REMARKS

AMENDMENTS TO THE DRAWINGS/FIGURES

Applicant: Richard M. Lloyd
Title: VEHICLE-BORNE SYSTEM AND METHOD FOR
COUNTERING AN INCOMING THREAT
Serial No.: 10/698,500
Docket No.: RAY-144J
Attorney: Iandiorio & Teska

FIG. 4

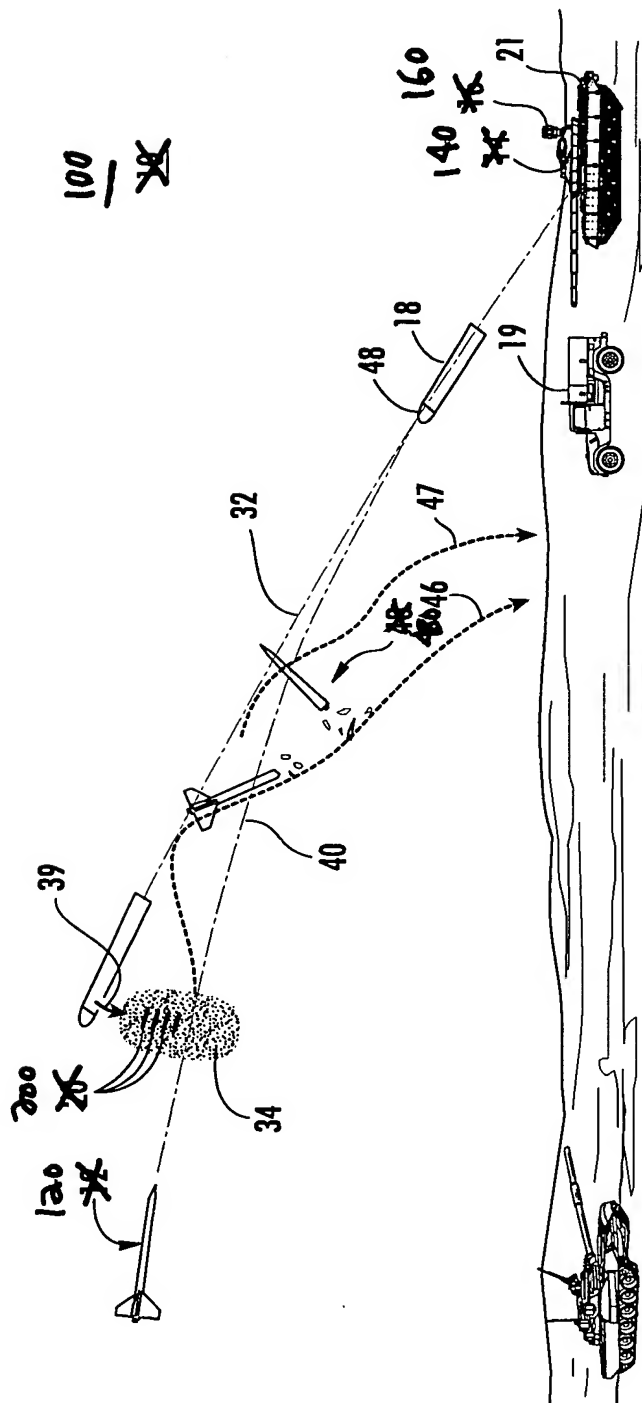
Additionally, the applicant has included proposed drawing changes corresponding to the changes in reference numeral designations in the specification. Particularly, the applicant proposes in Fig. 4 that references numerals 12, 20, 48, 14 and 16 be changed to 120, 200, 480, 140 and 160, respectively; also, in Fig. 5, that reference numeral 14 be changed to 140; in Fig. 6, that reference numeral 19 be changed to 190; in Fig. 7A, that reference numeral 16 be changed to 160; in Figs. 8A, 8B and 8C, that reference numerals 20 and 22 be changed to 200 and 220, respectively; in Fig. 8C, that reference numeral 24 be changed to 25; and in Fig. 9, that reference numerals 12, 20, and 10 be changed to 120, 200 and 100, respectively. Also in Fig. 9, the applicant proposes that reference numeral 18 be changed to 220. Additionally, the applicant proposes removal of the word "VEHICLE" in Fig. 9. Also, in Fig. 22, the applicant proposes that reference numerals 100, 102, 104, and 106 be changed to 1000, 1020, 1040, and 1060, respectively.

FIG. 22

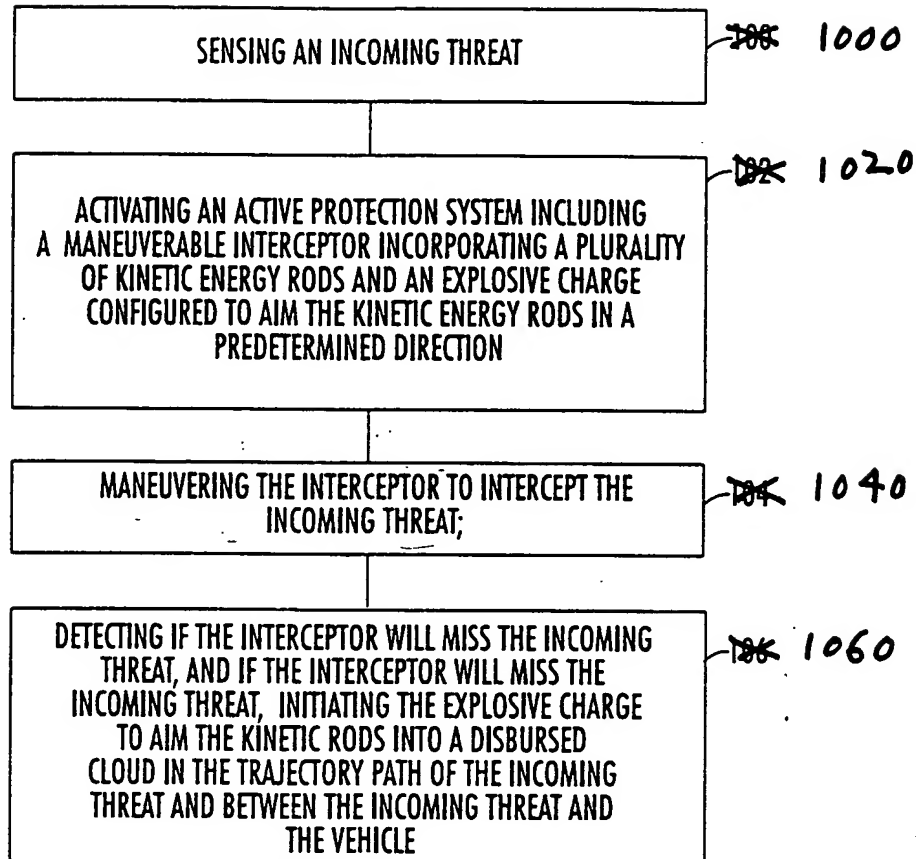
Additionally, on page 15, at line 18, the applicant proposes the addition of the words "maneuvering interceptor 18 to intercept incoming threat 120, Fig. 4, step 1040, Fig. 22". This addition is consistent with step 104 (now 1040) in the original drawings, and thus no new matter has been added.
